BOARD OF ZONING APPEAL

BZA Application Form

BZA Number: 211208

LOCATION OF PROPERTY: 18 Fairmont St , Cambridge, MA

**Exhibit B
Images**

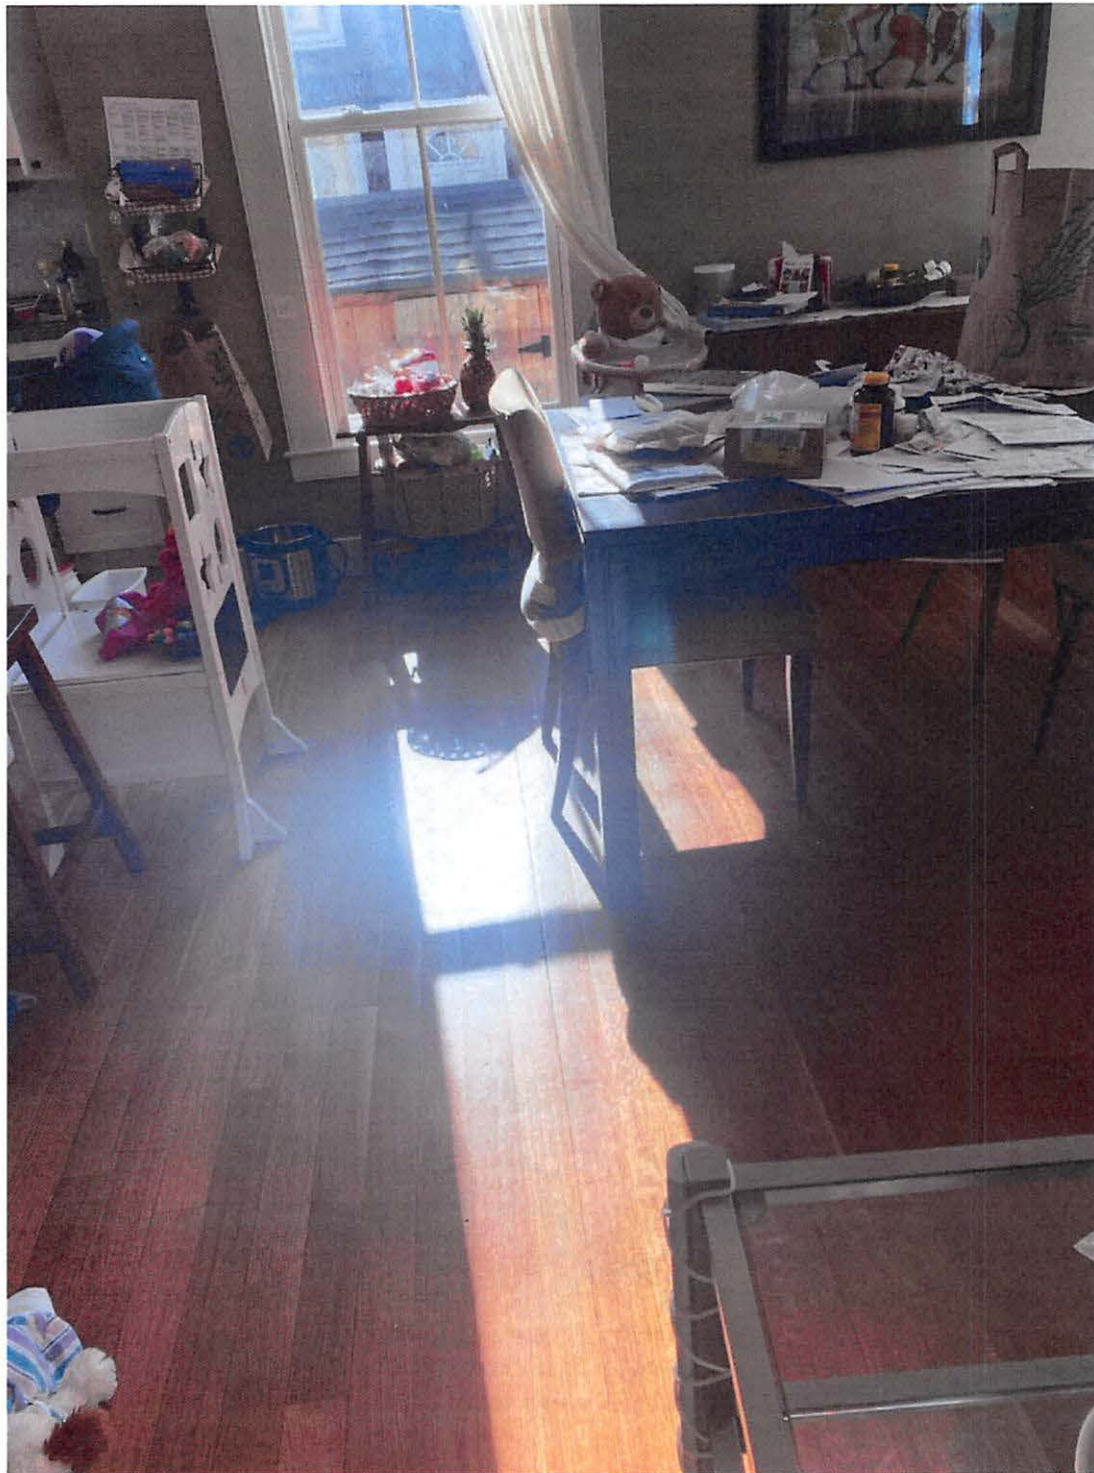
Morning light at 9:50am comes in over the 30 degree pitched roof in the rear and fills our kitchen, dining room, and living room with light. Increasing the height from 15' at the eave to 32.4' and moving the entire plane nearly 3' closer to us will block this light.

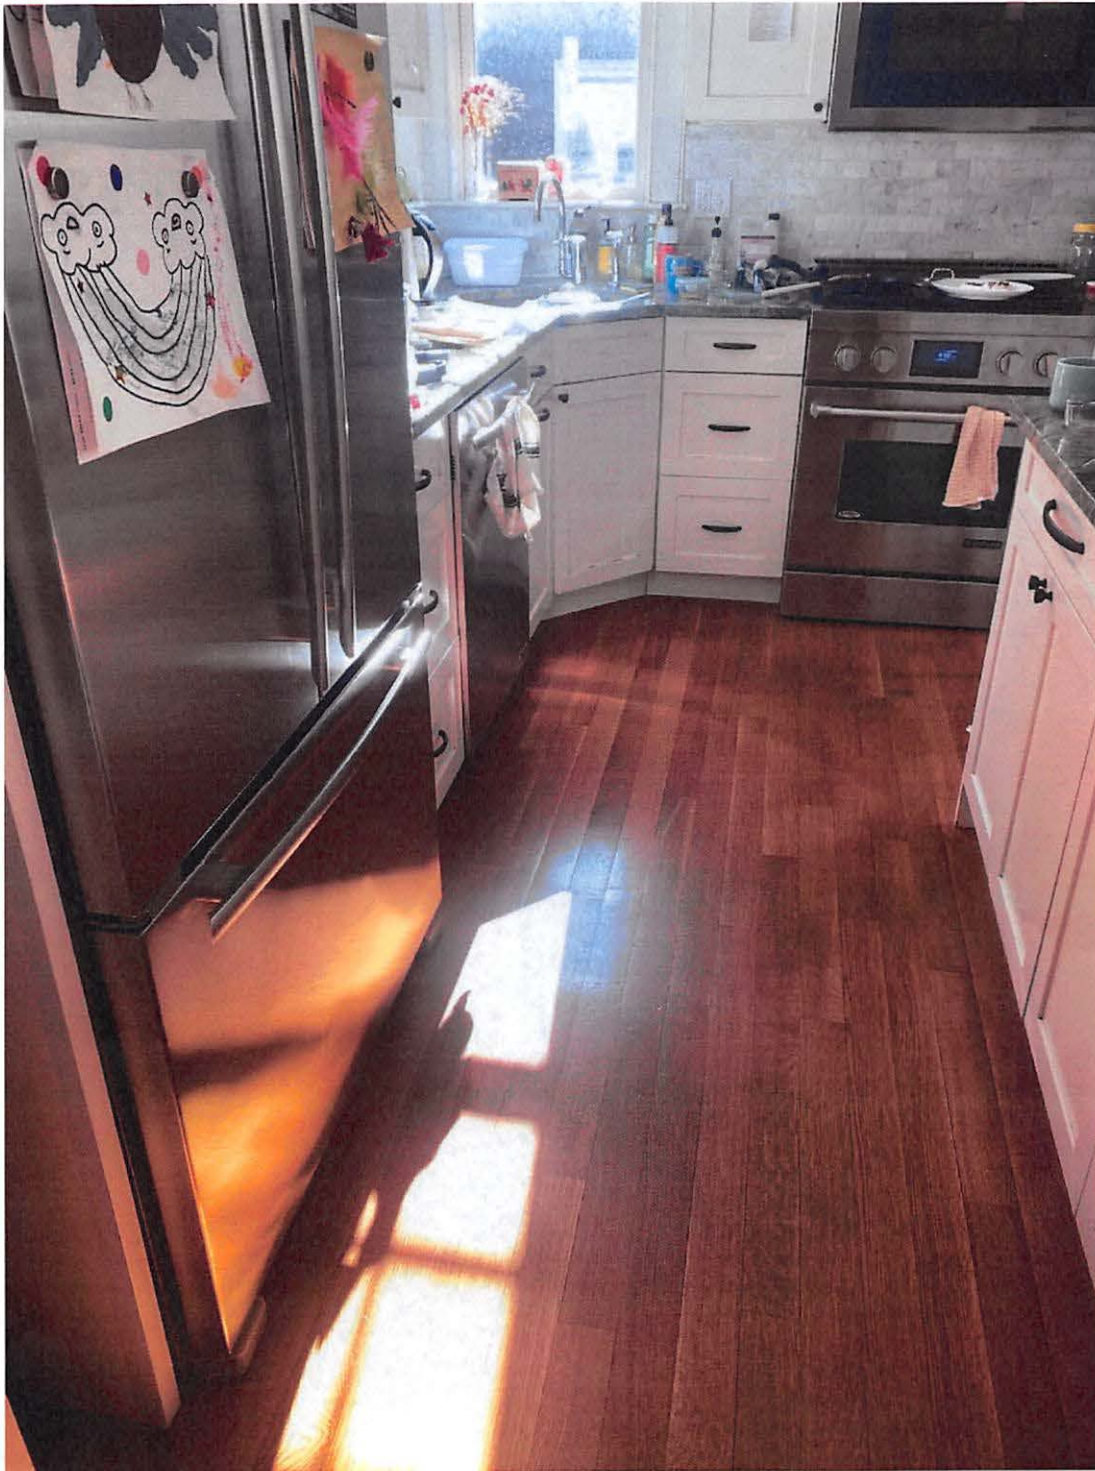
Morning light coming into our dining room on the first floor will be blocked.

Our kitchen is in the northeastern corner of our plan in the first floor. This morning light will be blocked.

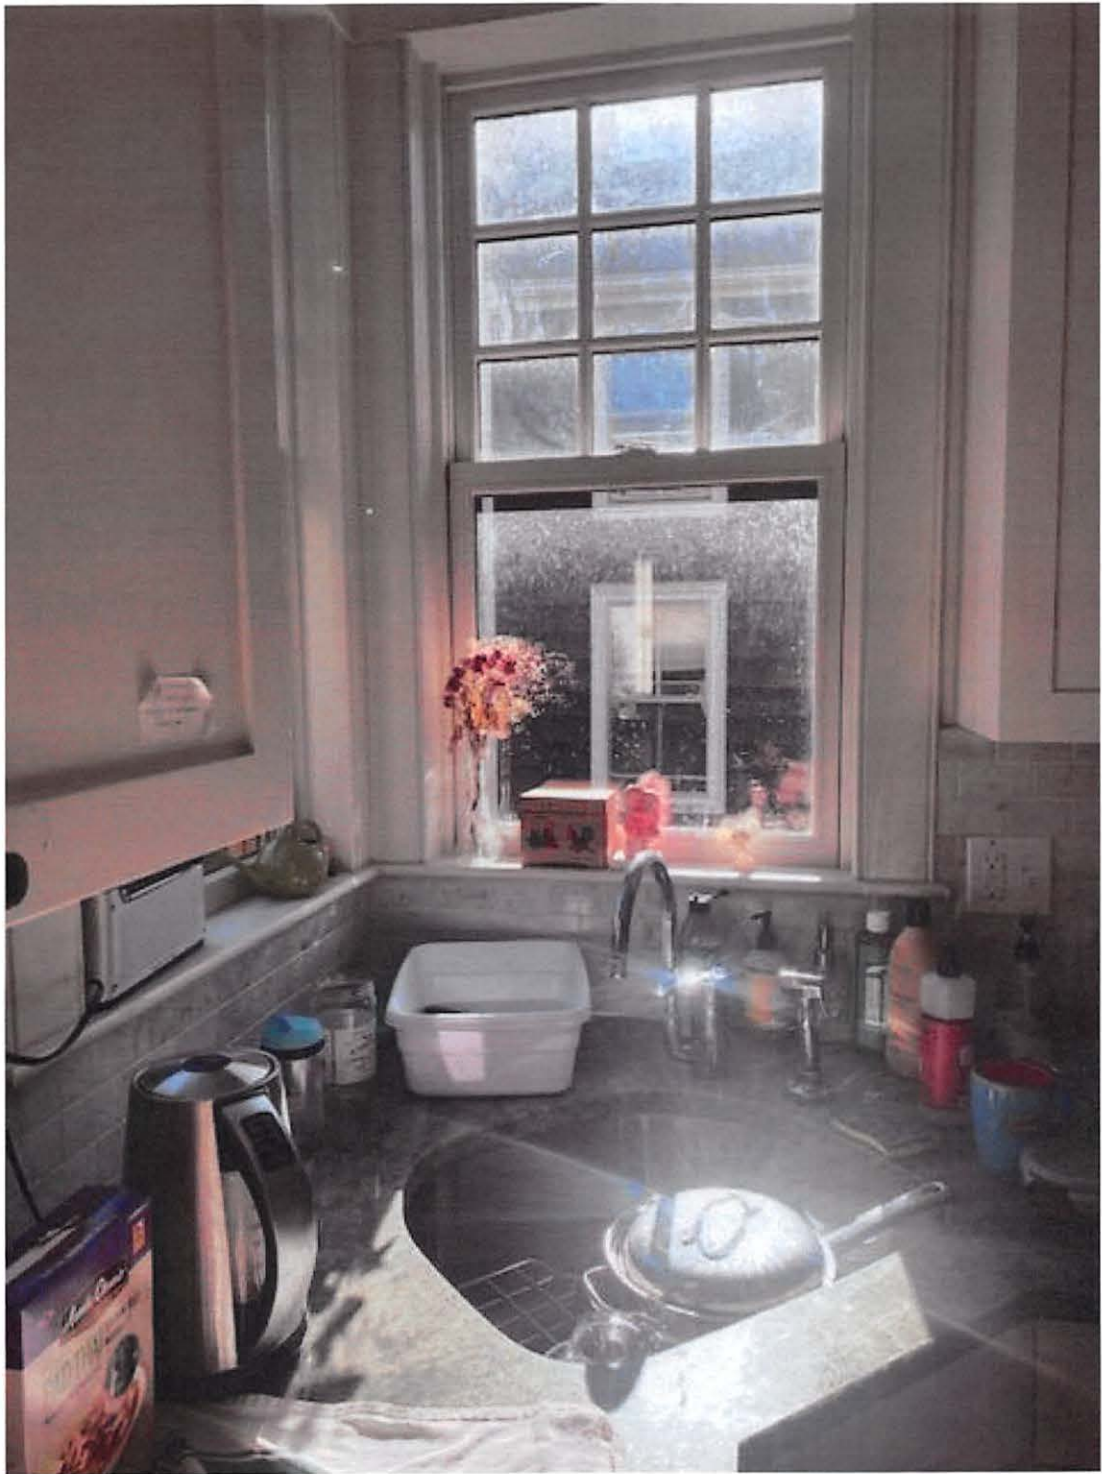
This is late morning – even that sun won't get through.

Morning light from southeast in kitchen will be blocked.

**Zoning - Setback
Plan - MULTIPLANE
CALCS- Zone C1**

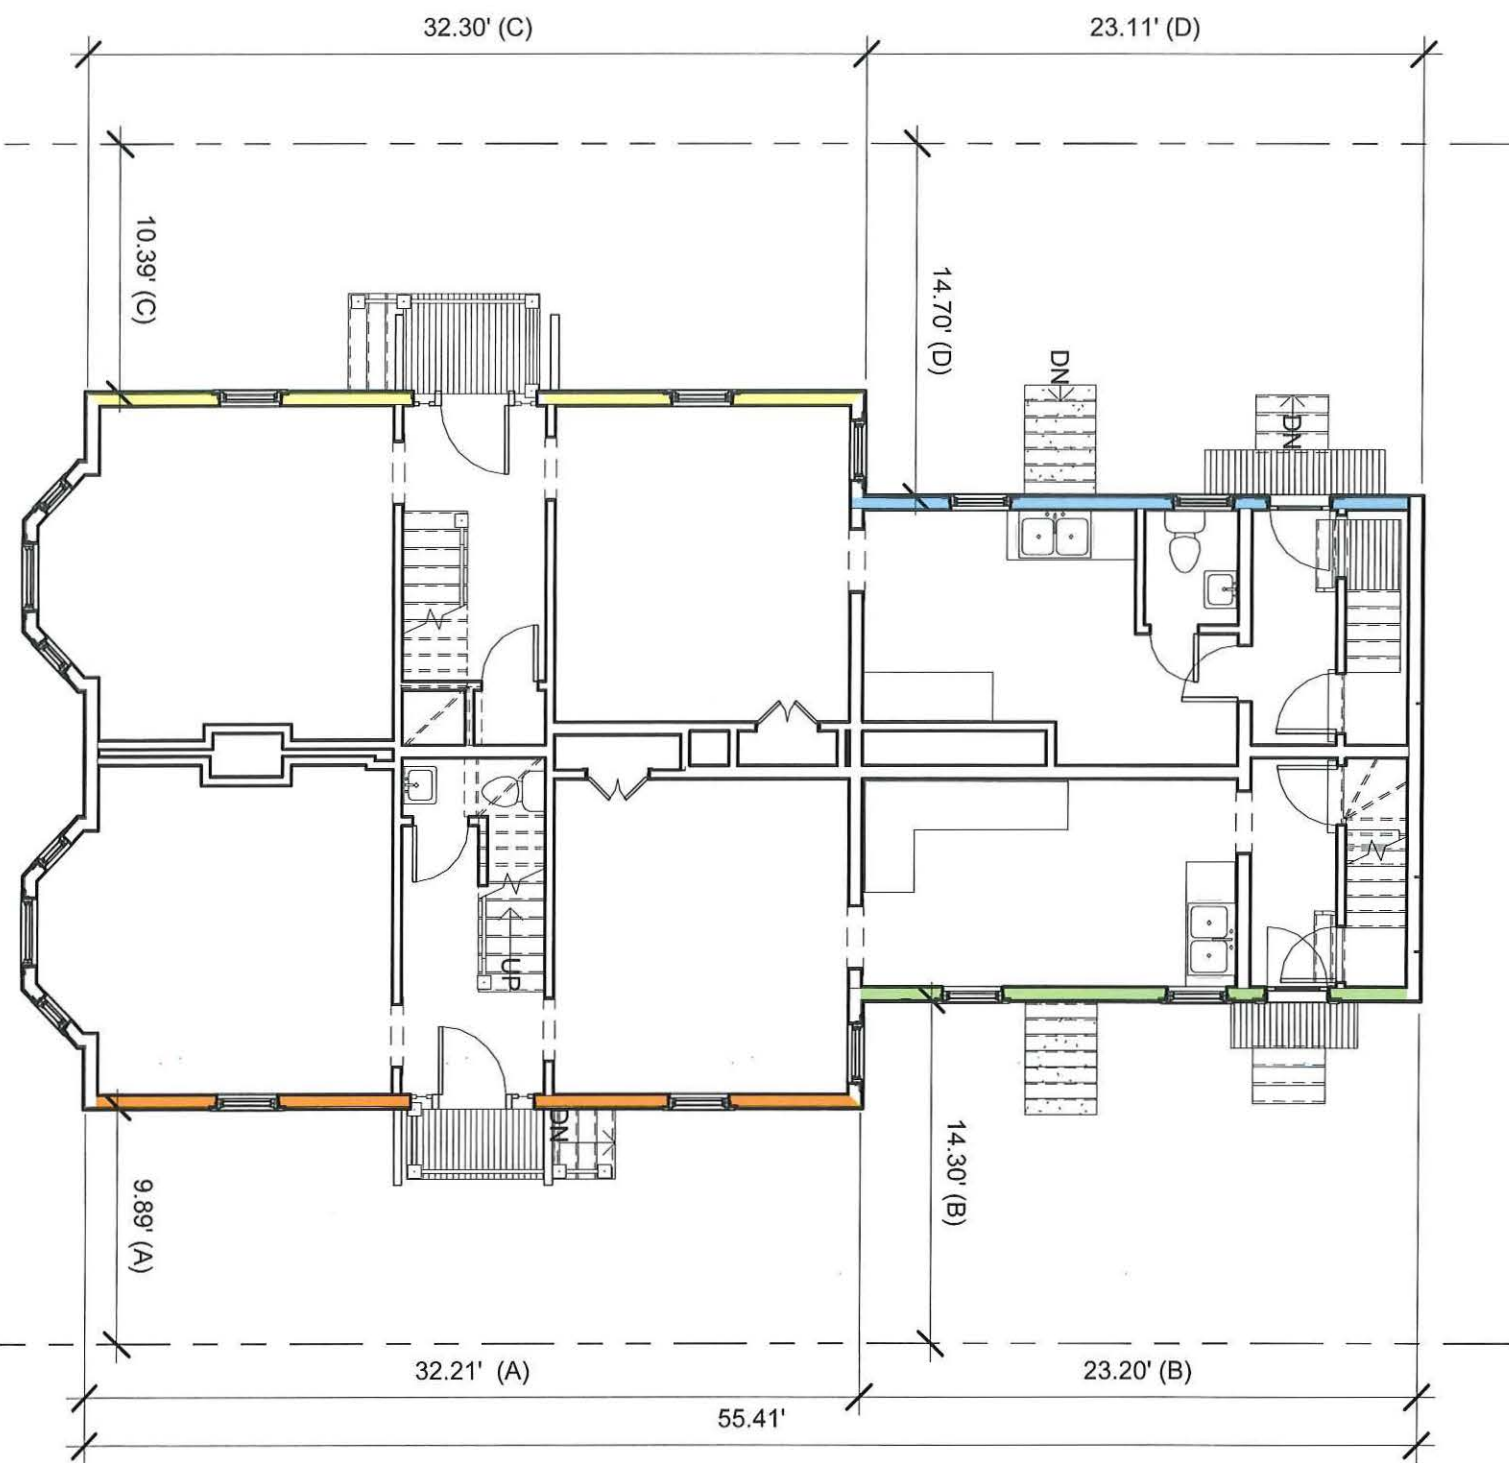
Second, the applicant did not correctly calculate the existing versus required side yard setbacks. According to the logic and spirit of the code, he should use average height and the multi-plane formula under 5.24, as well as the denominator of 7, to calculate the existing and required setback to show that the existing setback does not conform. (Choosing not to use such elements to create – in order to then increase – a nonconformity is not in keeping with the spirit or intent of the code.) The error of choosing 5 instead of 7 for the denominator in the H+L calculation vastly exaggerates the requirements to make the setbacks look nonconforming. These errors make it impossible to ascertain from the application whether the setbacks do or do not in fact conform.

EXTG. LEFT SIDE ELEVATION MULTIPLANE CALCULATION								
INDIVIDUAL PLANES CALCULATION						VOLUME CALCULATION		
PLANE	H	L	CALC. SETBACK (H+L/7)	EXTG. SETBACK	INDIVIDUAL PLANE CONFORMITY (MIN. 7'-6")	SETBACK for VOLUME calc.	AREA OF PLANE	VOLUME CALC. OF EACH PLANE
C	32.4	32.3	9.24	10.39	YES	10.39	1046.52	10873.34
D	23.29	23.11	6.63	14.7	YES	14.7	538.2319	7,912
TOT.							1,585	18,785

SINGLE PLANE CALCULATION								
PLANE	H	L	CALC. SETBACK (H+L/7)				AREA OF PLANE	VOLUME CALC. OF SINGLE PLANE
SINGLE	32.4	55.41	12.54				1,585	19,880

EXTG. RIGHT SIDE ELEVATION MULTIPLANE CALCULATION								
INDIVIDUAL PLANES CALCULATION						VOLUME CALCULATION		
PLANE	H	L	CALC. SETBACK (H+L/7)	EXTG. SETBACK	INDIVIDUAL PLANE CONFORMITY (MIN. 7'-6")	SETBACK for VOLUME calc.	AREA OF PLANE	VOLUME CALC. OF EACH PLANE
A	32.4	32.3	9.24	9.89	YES	9.89	1046.52	10350.08
B	23.29	23.11	6.63	14.3	YES	14.3	538.2319	7,697
TOT.							1,585	18,047

SINGLE PLANE CALCULATION								
PLANE	H	L	CALC. SETBACK (H+L/7)				AREA OF PLANE	VOLUME CALC. OF SINGLE PLANE
SINGLE	32.4	55.41	12.54				1,585	19,880

FOR BOTH RIGHT AND LEFT CALCULATION, THE INDIVIDUAL PLANE CALCULATION IS CONFORMING FOR EACH PLANE (A,B,C AND D).

HOWEVER, THE SINGLE PLANE CALCULATION IS NOT CONFORMING, THEREFORE THE EXGT. SETBACKS CALCULATED USING THE MULTIPLANE CALCULATION ARE NON CONFORMING (ART. 5.24.4.3)
